## CCPS RFP#25-04 – NORTH EAST MIDDLE/HIGH SCHOOL REPLACEMENT PROJECT

### ADDENDUM #7

**This addendum is to provide the pre-bid agenda and attendance list and issued revisions to the contract documents as noted below.** Proposers and related parties will be responsible for reading and understanding all documents, the scope of work, addenda and all related solicitation documents issued. These documents will become attached to and part of the solicitation and award of bid contract.

1. **ASIs 01 and 02**
2. **PR 01**
3. **CLOSED RFIs 001- 0027, 029-031, 034. (open RFIs are excluded)**

A14 ELEVATOR 3 - LEVEL 1 FLOOR PLAN  
1/4" = 1'-0"

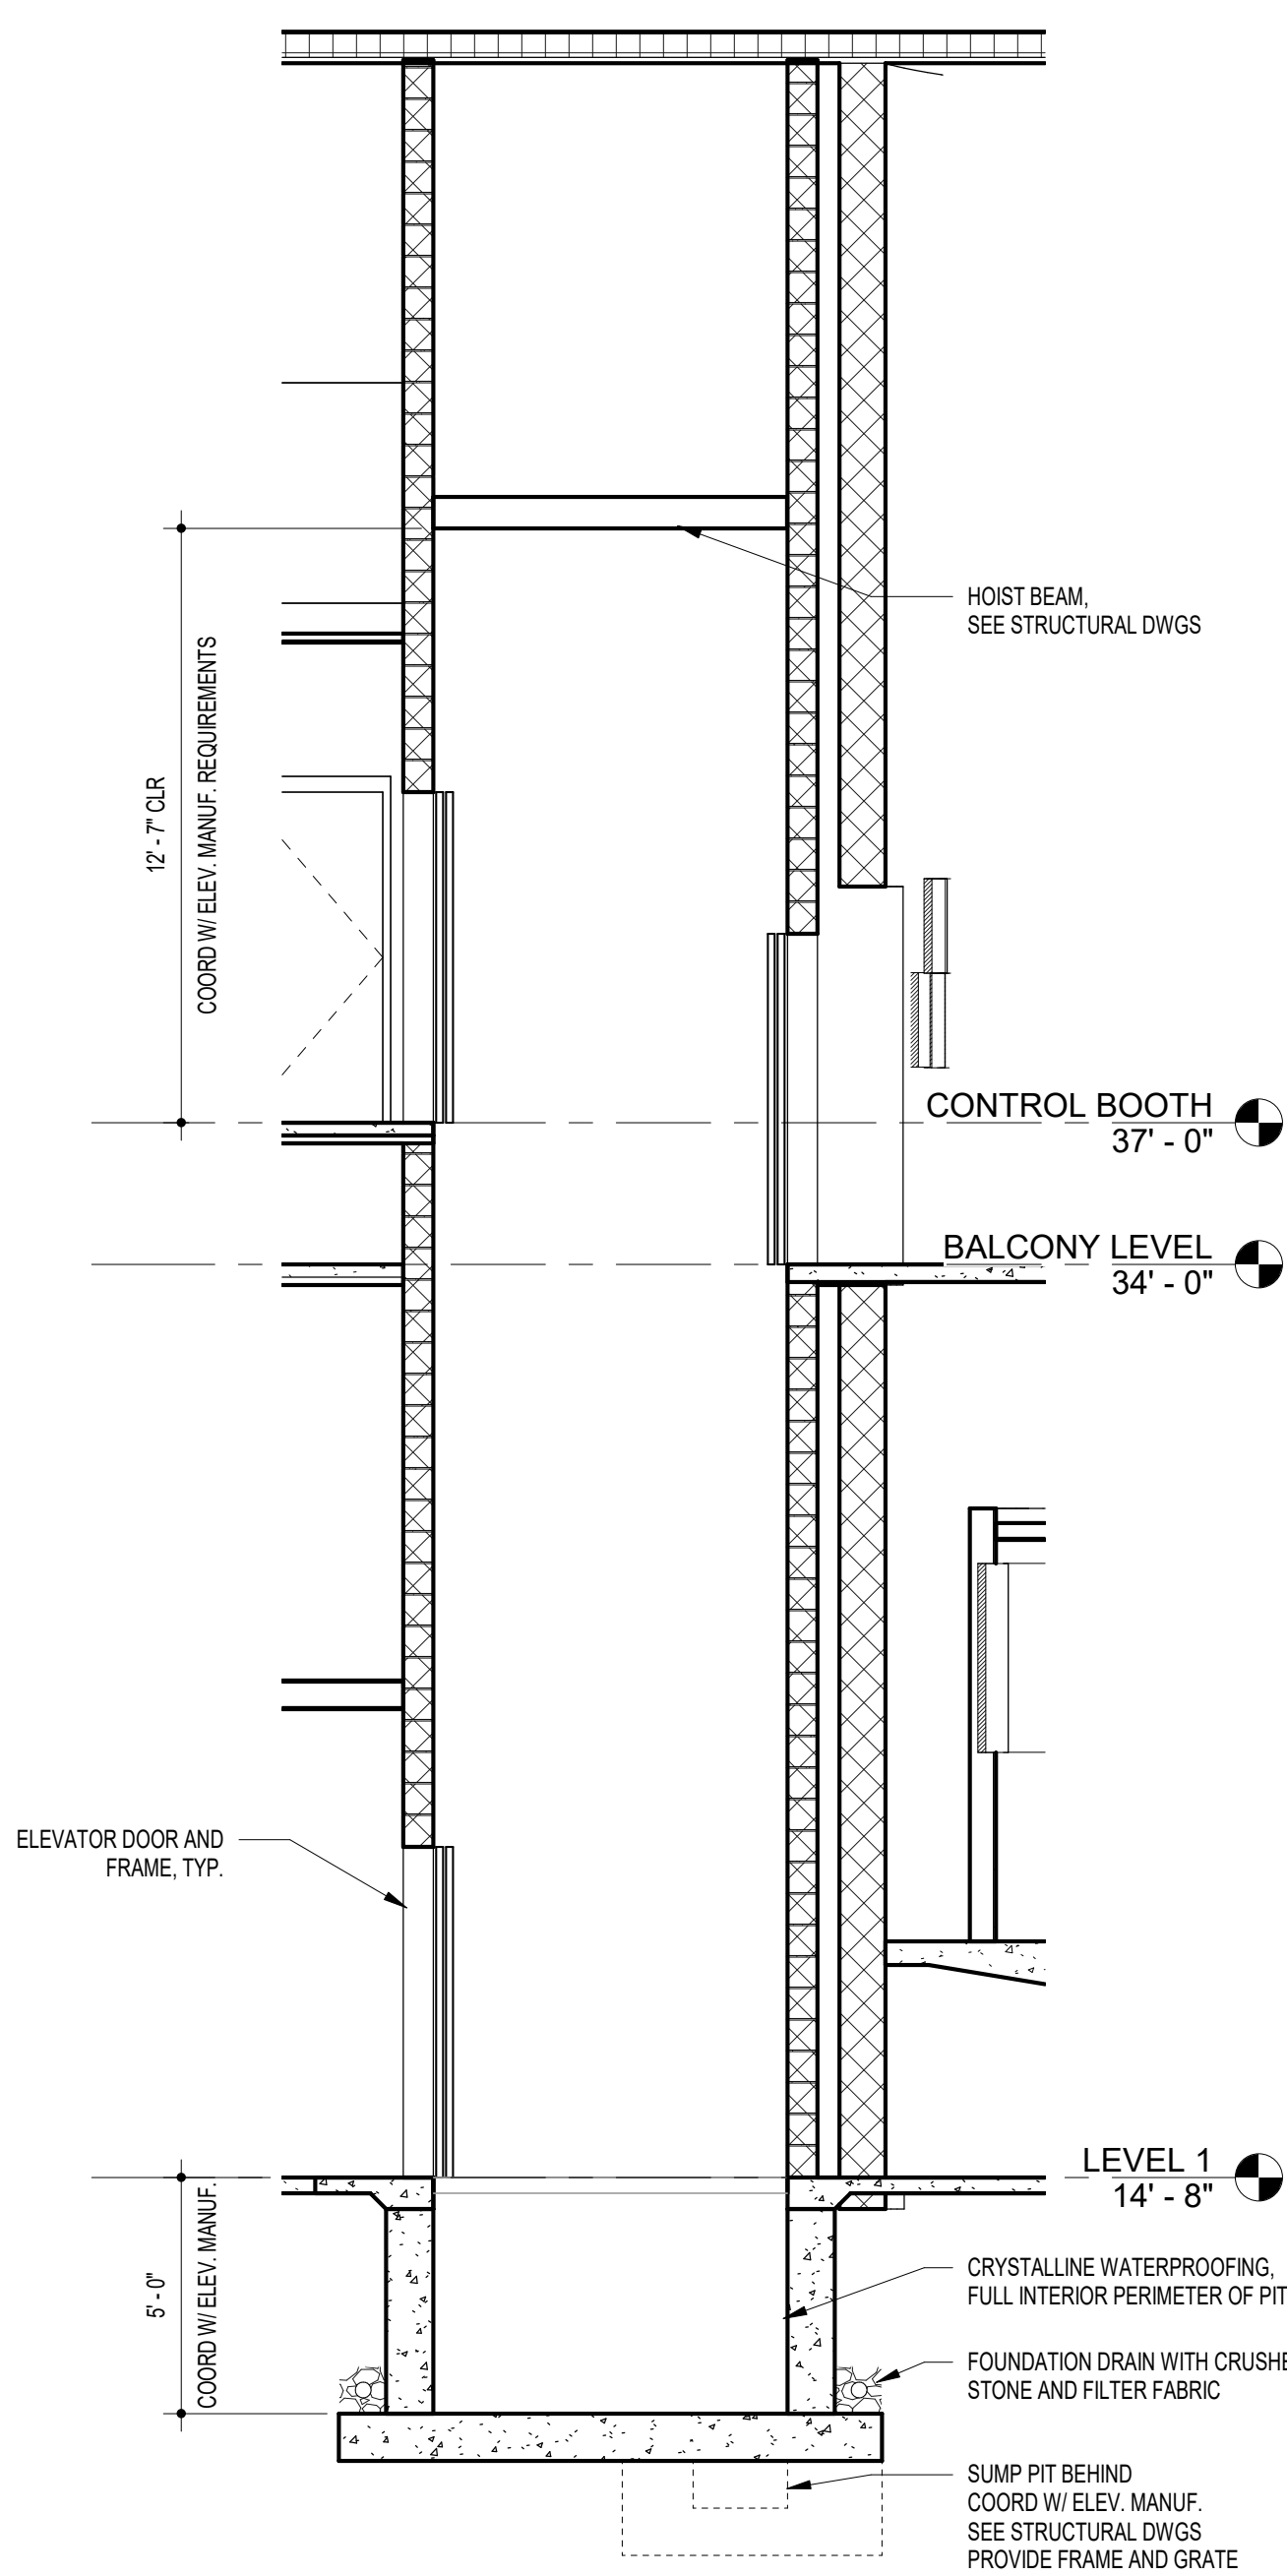
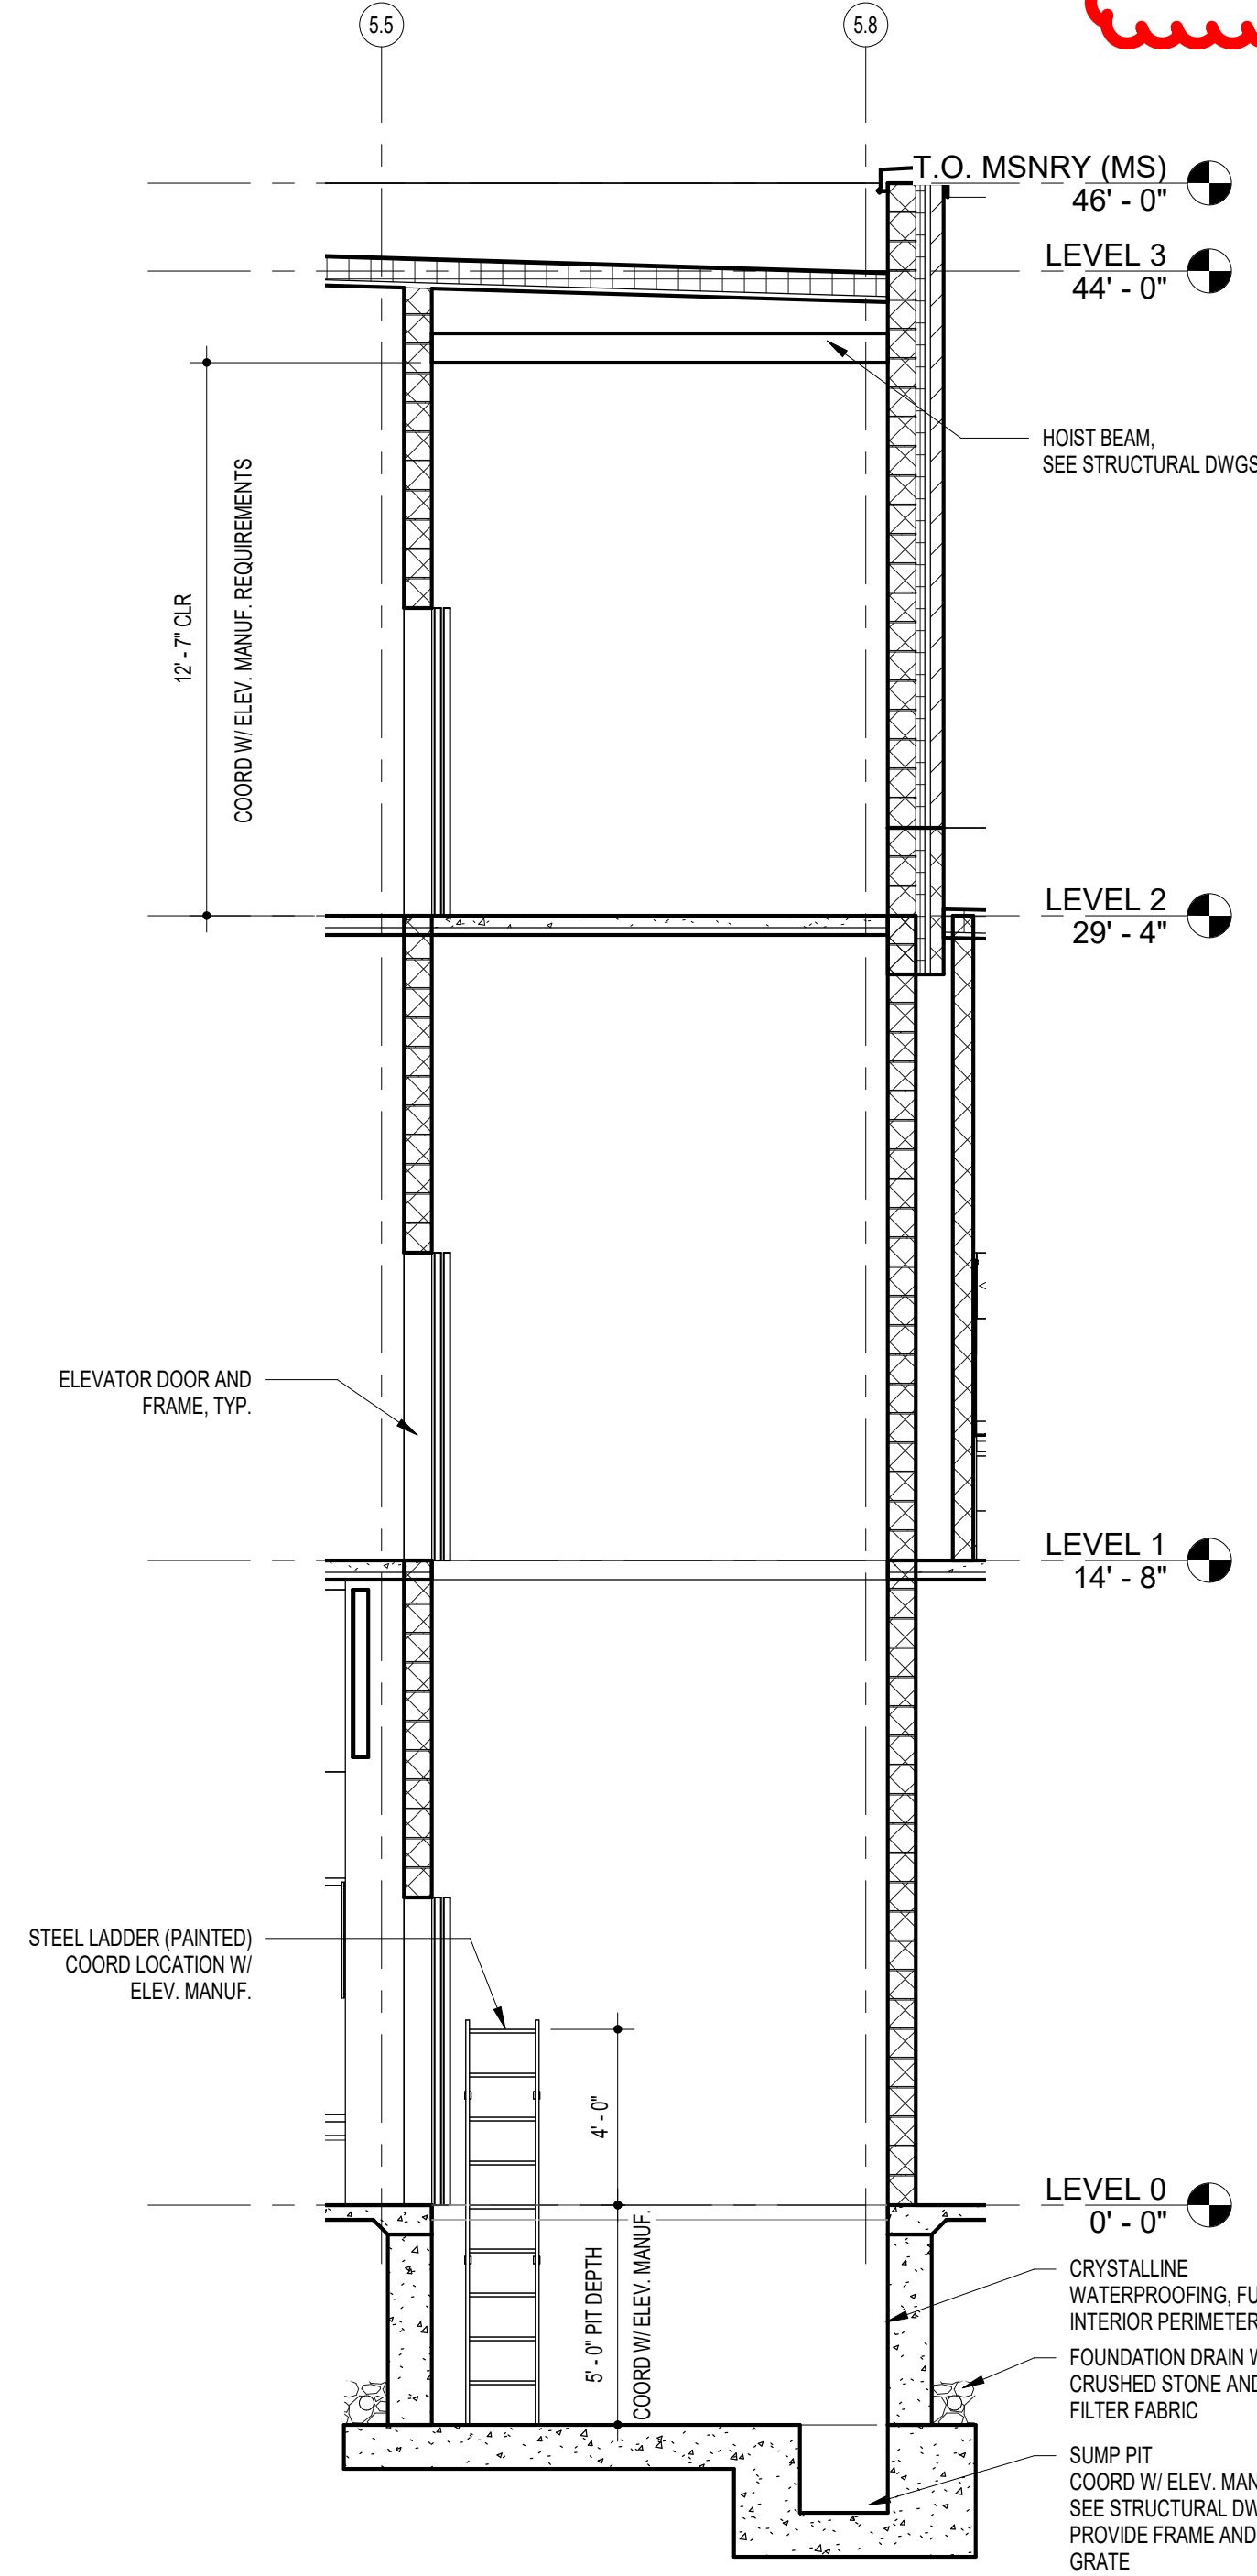
- o Sill A18/A425
- o Obtuse corner A101D (A'/1#) - please provide angle (105deg?)
- o Acute corner A101D (CL-C'/1#)- please provide angle (75deg?)
- o Obtuse corner K10/A519- please confirm 105deg angle
- o Obtuse corner H4/A518- please confirm 105deg angle
- o Please note that the chamfered building stone call out on sheet A101E (at corner CL-D'/1#) cannot be manufactured. Please confirm use of a straight joint is acceptable.

1. See attached detail on sheet A425 for dimensions.
2. 105 degree interior angle is correct.
3. 75 degree interior angle is correct.
4. 105 degree interior angle is correct.
5. 105 degree interior angle is correct.
6. Use of straight joint is not acceptable. We are working with the manufacturer on the creation of a custom cast piece and will advise of final solution.

**A425**

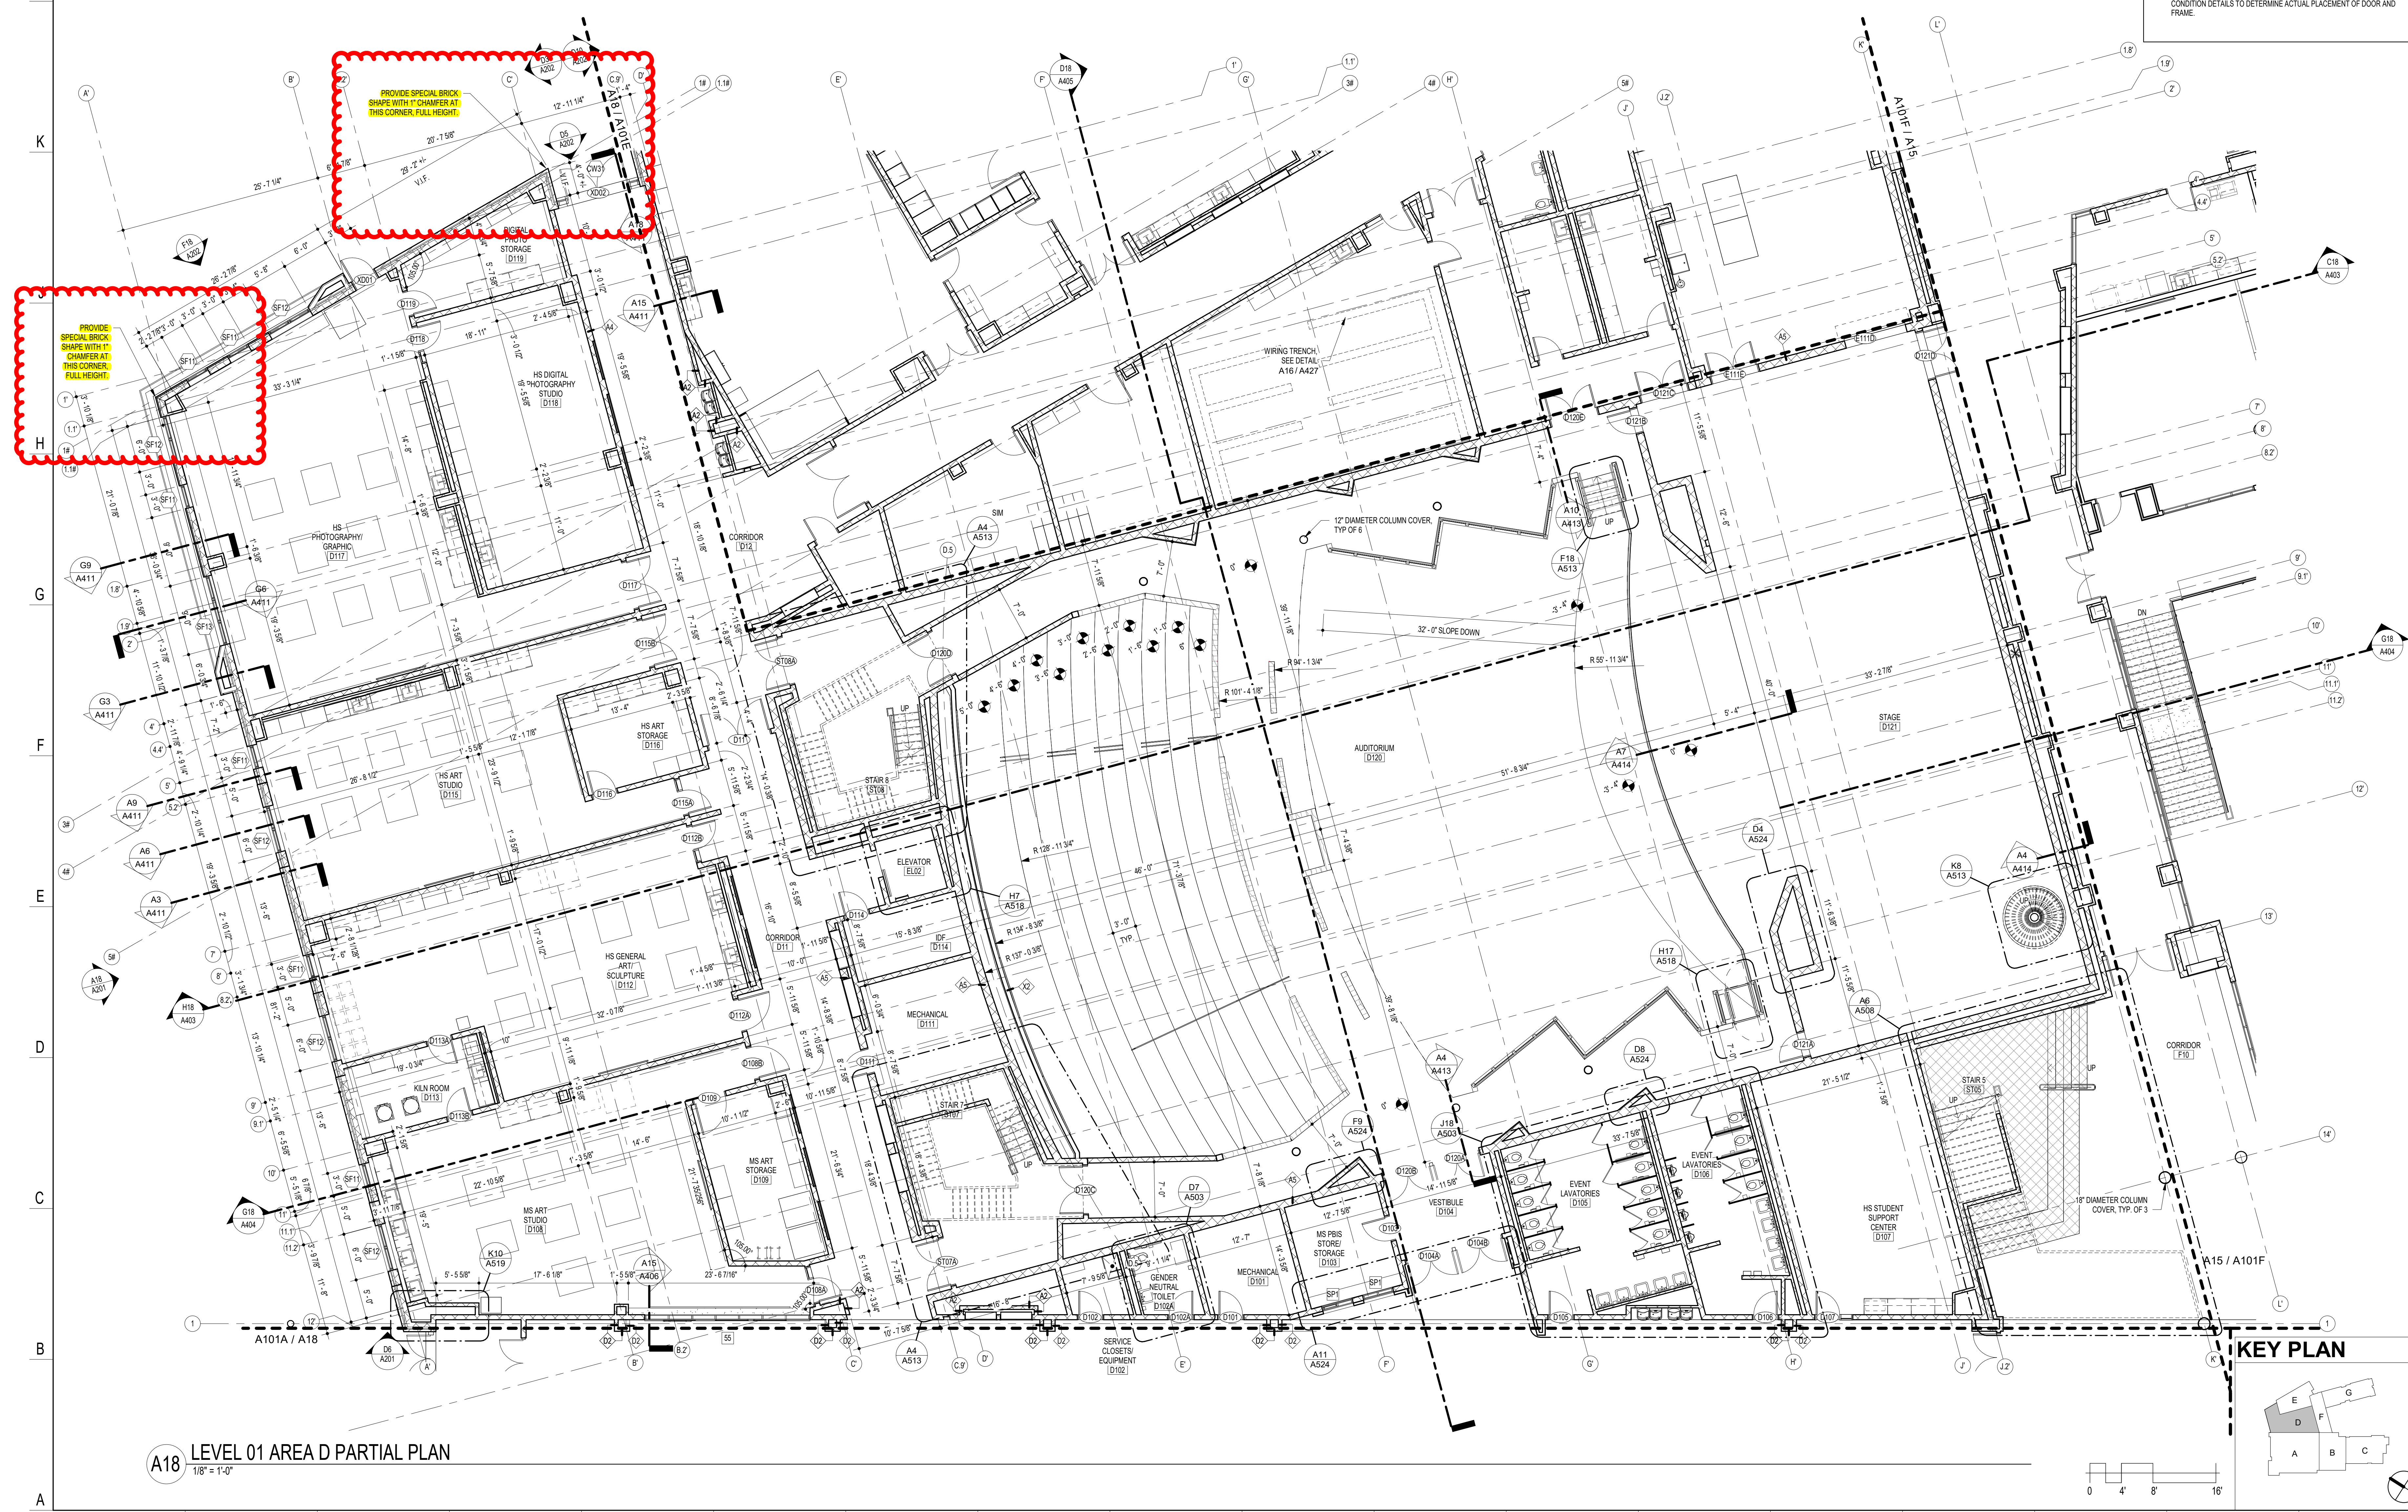
- o Sill A18/A425
- o Obtuse corner A101D (A'/1#) - please provide angle (105deg?)
- o Acute corner A101D (CL-C'/1#)- please provide angle (75deg?)
- o Obtuse corner K10/A519- please confirm 105deg angle
- o Obtuse corner H4/A518- please confirm 105deg angle
- o Please note that the chamfered building stone call out on sheet A101E (at corner CL-D'/1#) cannot be manufactured. Please confirm use of a straight joint is acceptable.

1. See attached detail on sheet A425 for dimensions.
2. 105 degree interior angle is correct.
3. 75 degree interior angle is correct.
4. 105 degree interior angle is correct.
5. 105 degree interior angle is correct.
6. Use of straight joint is not acceptable. We are working with the manufacturer on the creation of a custom cast piece and will advise of final solution.
